Oyster Creek Nuclear Generating Station
Renewed Facility Operating License No. DPR-16
Docket Nos. 50-219 and 72-15

Subject: Oyster Creek Nuclear Generating Station ISFSI Only Security Plan, Training Qualification Plan, Safeguards Contingency Plan Supplemental Information

By letter dated December 8, 2020 (Reference 1), Holtec Decommissioning International, LLC (HDI) submitted a License Amendment Request (LAR) for approval of the proposed Oyster Creek Nuclear Generating Station ISFSI Only Security Plan. On December 21, 2020, HDI received a letter from the US Nuclear Regulatory Commission (NRC), documenting their Acceptance Review (Reference 2). Reference 2 also provided two Requests for Supplemental Information (RSIs).

Site Maps Depicting the layout of the ISFSI

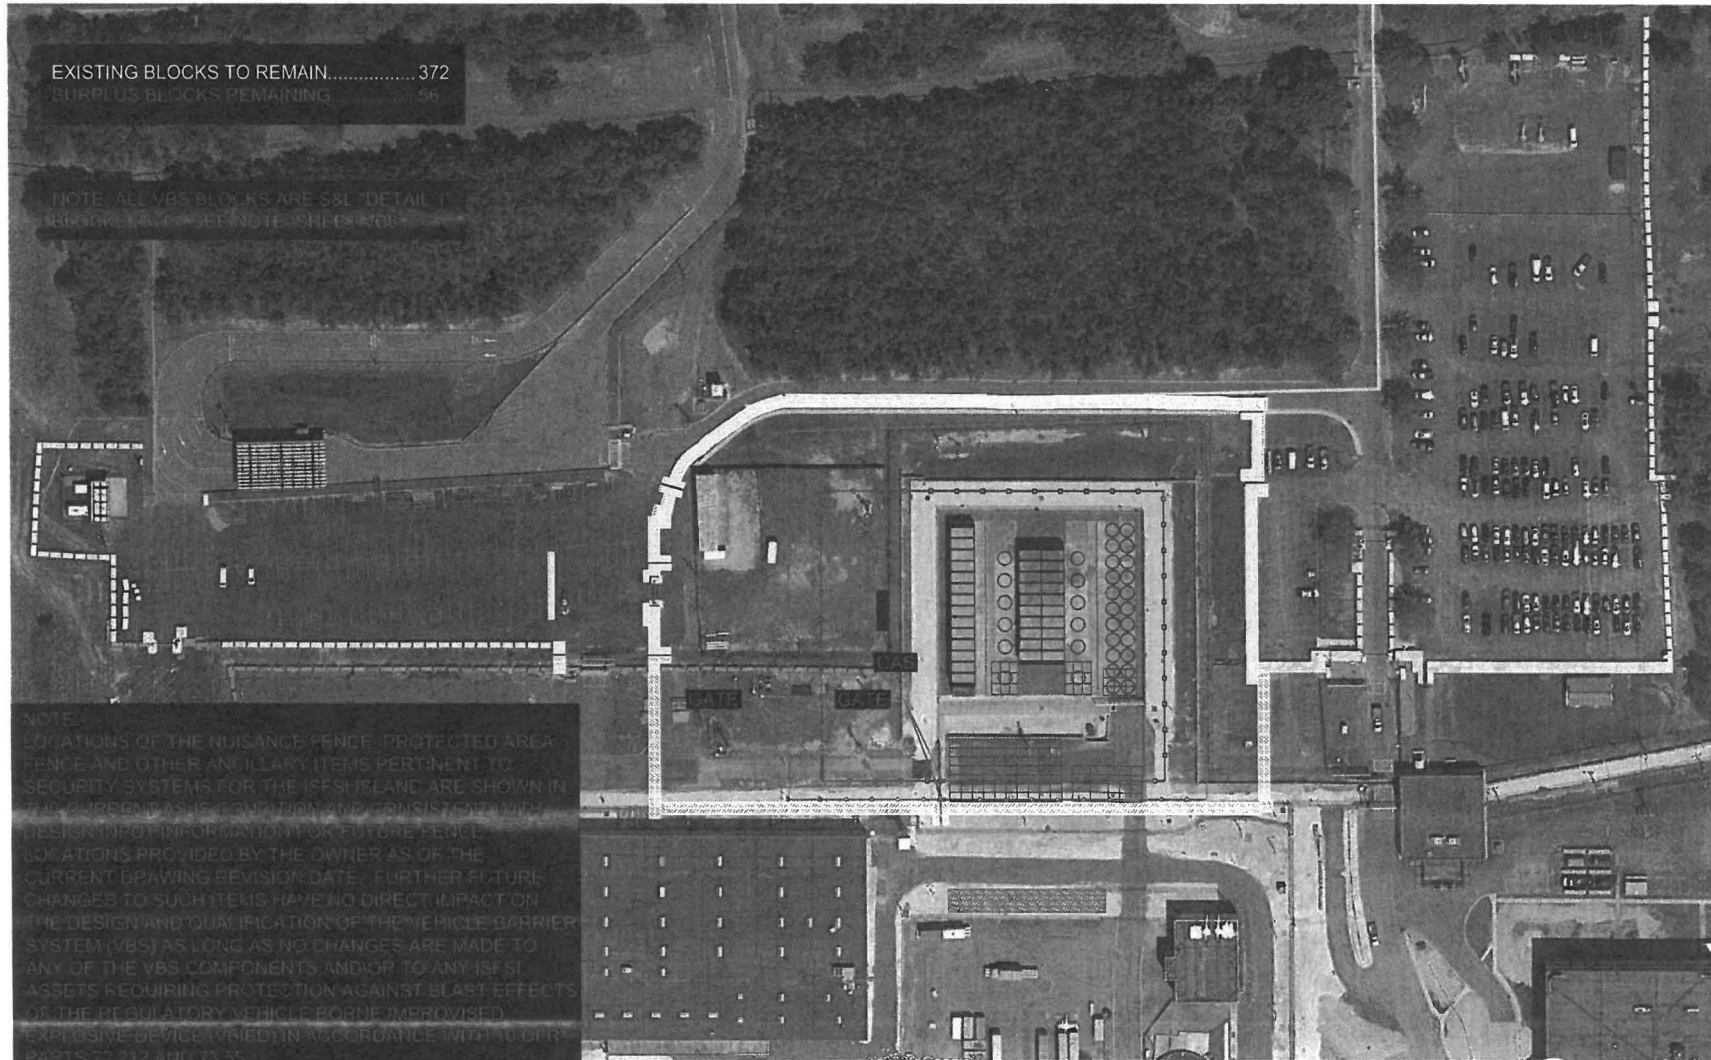
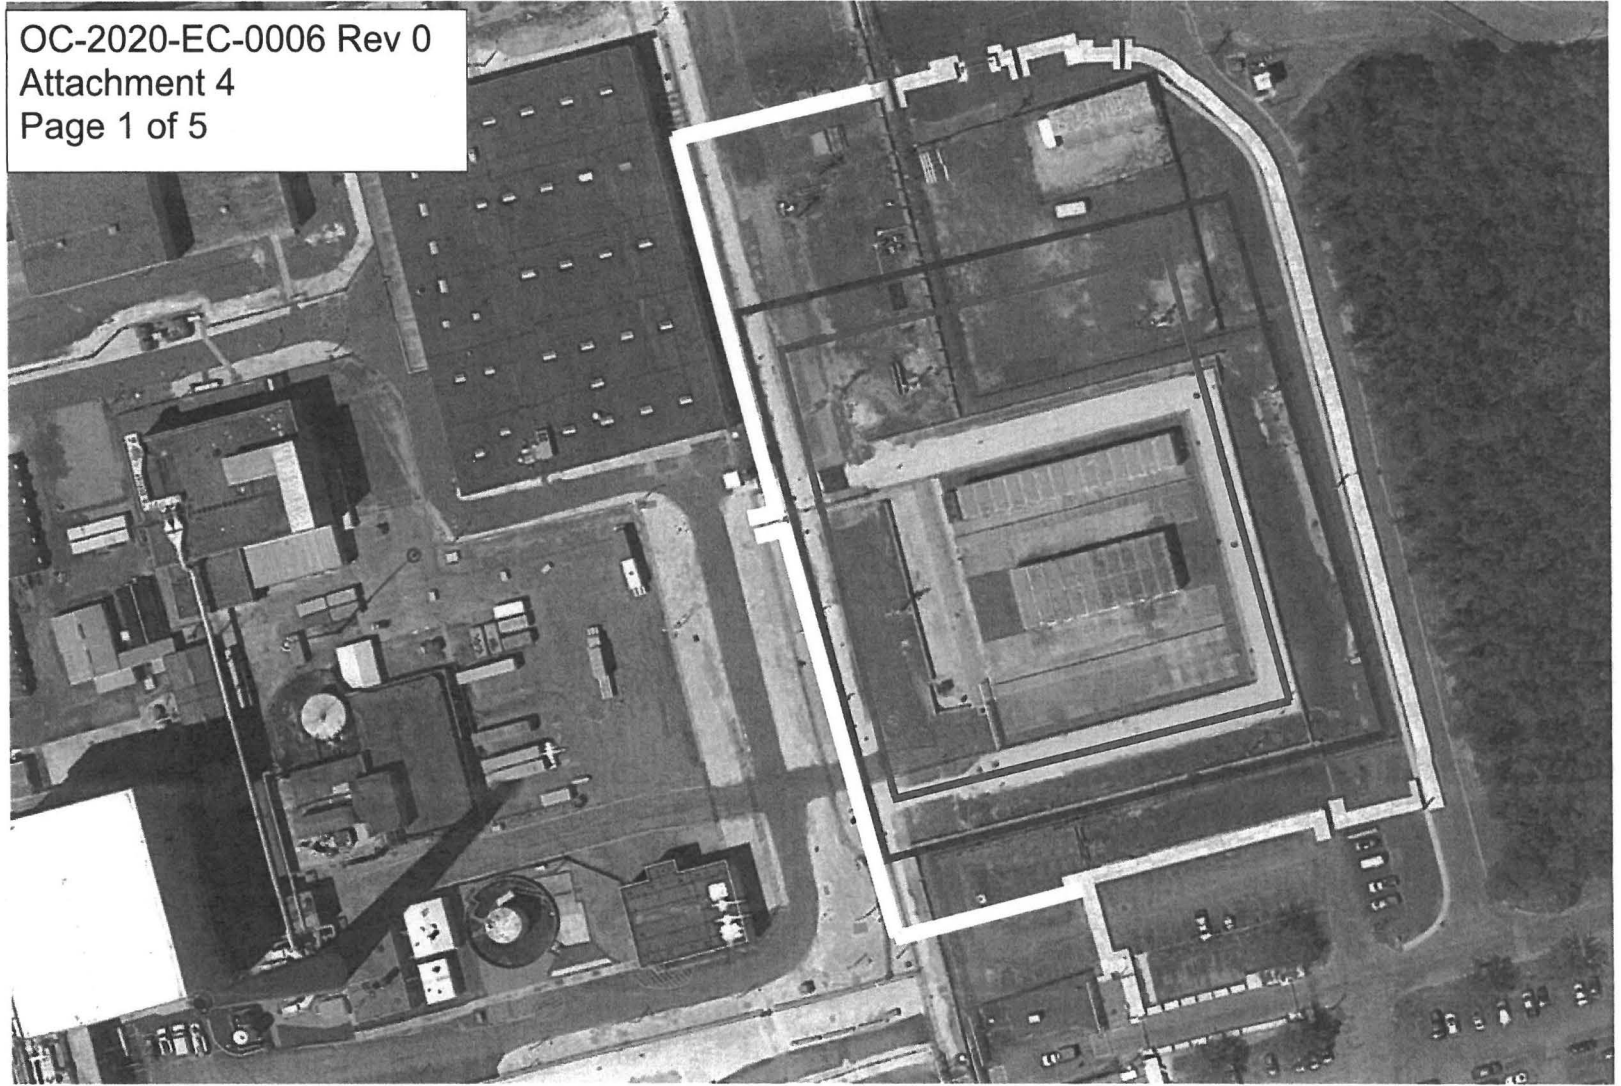
- 1) *The OCNCS ISFSI PSP does not address how this PSP will meet the requirements of NRC Order EA-02-104. This information is needed to meet the requirements of NRC Order EA-02-104.*
- 2) *The OCNCS PSP contains figures and diagrams of the Oyster Creek ISFSI layout that are blurred. This information is needed to determine compliance with 10 CFR 73.55(a)-(r), and NRC Order EA-02-104.*

Figures and Diagrams in the Attachments and Enclosures have been revised to improve quality and clarity where needed. In addition, the Tables in the Kontek CAS description provided in Attachment 5 are reproduced in Enclosure 7 to provide additional clarity.
